ADDENDUM NO. 3
Water Treatment Plant GAC Facility
City of Cynthiana
Cynthiana, Kentucky

**RFI'S FROM CONTRACTORS
ADDENDUM NO. 3**

**WATER TREATMENT PLANT GAC FACILITY
City of Cynthiana
Cynthiana, Kentucky**

PROJECT NO. 25009
SHEET NO. C-0-3

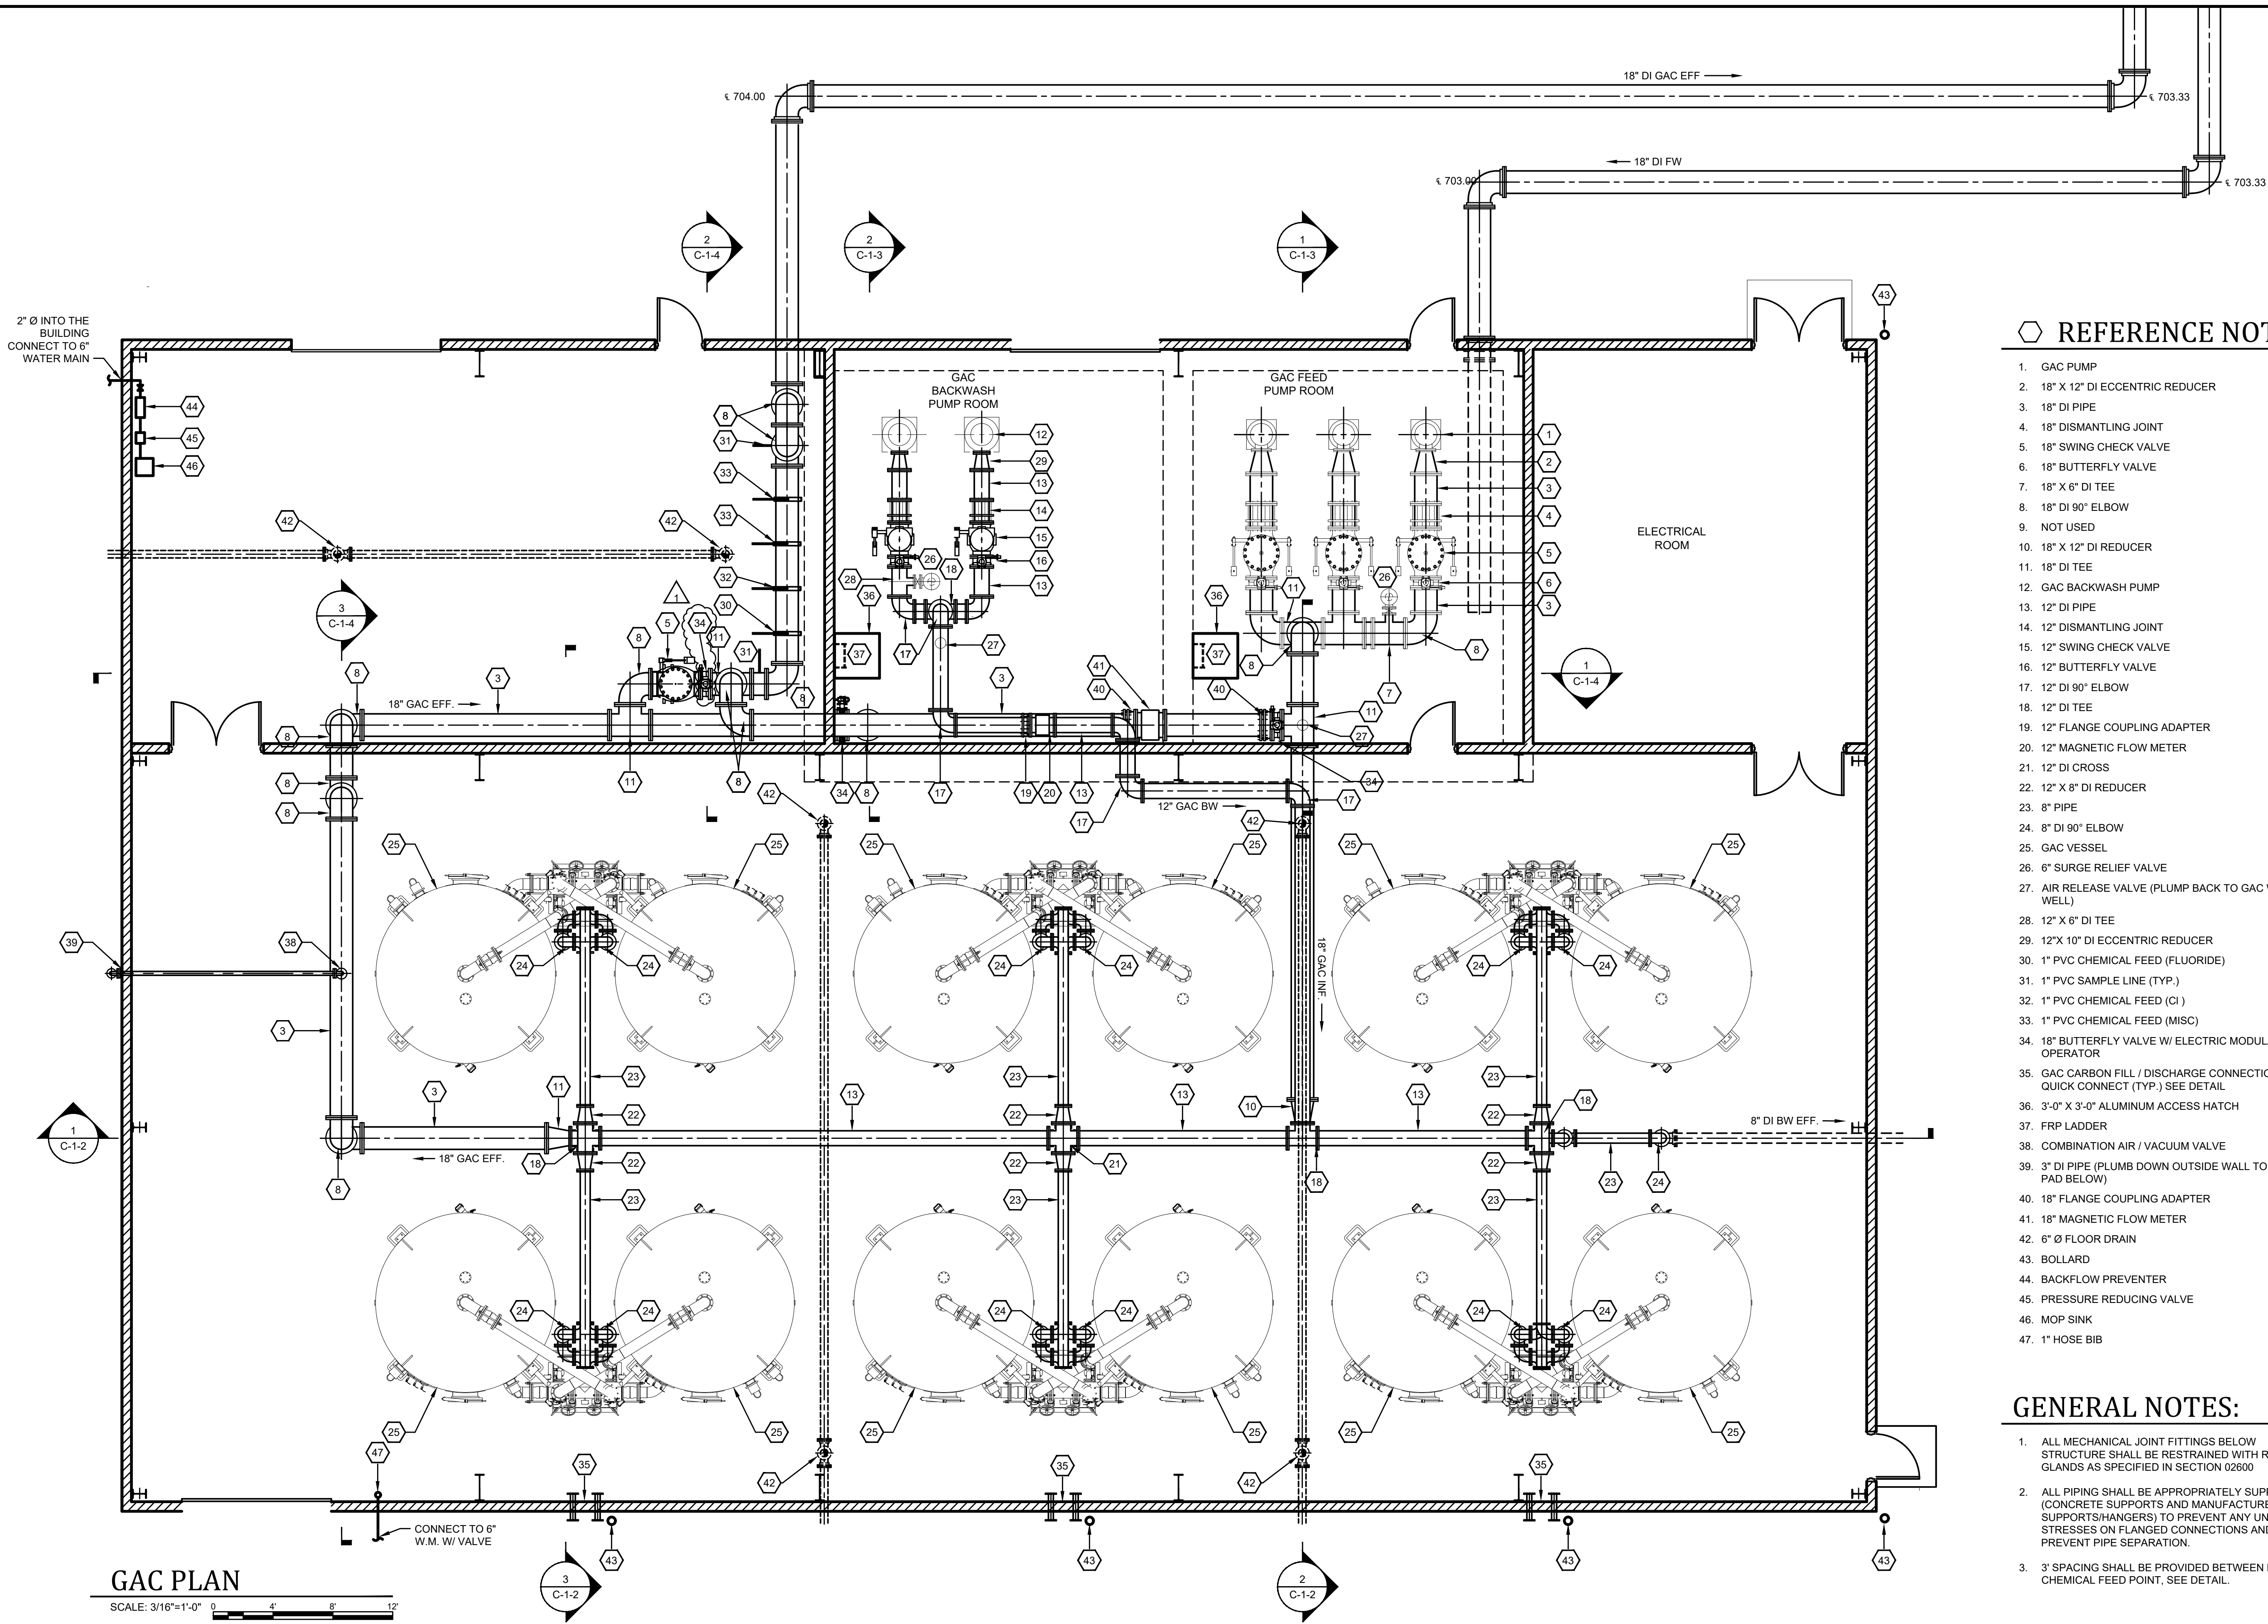
3. Plan sheet C-0-3 reference notes for the chemical feed conduit/tubing shall be modified. Reference Note 2 pertains to the Fluoride feed line and Reference Note 11 pertains to the Chlorine feed line and Miscellaneous feed line. Revised plan sheet C-0-3 is attached.
4. Revised plan sheets C-1-1, SD-2 and A-1-04 are attached as addressed in the RFIs.

3. *On Sheet C-0-3, Reference Note 2 calls for "Chemical Feed Flexible Tubing Installed in 2" PVC Conduit". Please confirm two of these lines are the sample lines required by General Note 4 on Sheet C-1-4 ("Sampling Tubing Shall be Installed in a 2" Conduit & Extended to a Point of Termination in the Lab"). Additionally, please confirm what material the third line is carrying and the connection details.*

4. *On Sheet C-0-3, Reference Note 5 calls for a "Cleanout See Detail, Sheet SD-2". Please provide the applicable detail.*

5. *On Sheet C-0-3, the exterior run of floor drain piping appears to be 6" PVC. The interior floor drain piping type is not called out, but Ductile Iron fittings appear to be indicated. Please confirm the interior floor drain piping is to be PVC.*

11. *Referencing Sheet C-0-3, General Note 1 requires that all yard piping 4" and larger be ductile iron. The site piping plan shows a 6" PVC drainpipe. Please confirm the 6" drainpipe shall be PVC as stated and advise if Schedule 40 or 80 is preferred.*

12. *Referencing Sheet C-0-3, the 6" PVC drainpipe is gravity fed to the existing pump station. Please advise of the preferred gradient and invert elevation of which the piping should enter the existing pump station wet well.*

16. *Referencing Sheet C-0-3, three chemical feed casing pipes run from the new construction to the existing filter building and an existing chemical feed shed. Please advise on the piping/casing/tubing entry details and the required plumbing connections necessary within these buildings as well as the new construction.*

RESPONSE: No, sample lines to the lab are not required. General Note 4 on Sheet C-1-4 shall be deleted. One conduit/tubing shall go to the fluoride building and two conduits/tubing shall go to the main treatment plant building. See RFI question #17 for connection information.

RESPONSE: See attached revised sheet SD-2 with Cleanout detail included

RESPONSE: The interior floor drain piping shall be PVC.

RESPONSE: The drainpipe shall be Schedule 80 PVC

RESPONSE: approximately 1% slope to the existing wet well

RESPONSE: For the fluoride cut in a tee on the existing feed line and add two ball valves. The intent is to be able to select between the existing feed line and the new feed line using the ball valves. The conduit shall daylight and go through the wall of the existing plywood building similar to the existing. The two lines to the main treatment building shall be 4" PVC conduit with 2" reinforced PVC tubing. Each conduit shall be cored through the existing concrete wall into the crawl space. The chlorine shall extend up through the concrete floor near the existing chlorinators and connected to the existing feed line with a new tee and two ball valves. The miscellaneous 4" conduit/2" tubing shall be terminated in the crawl space directly under the chlorine rotameter room.
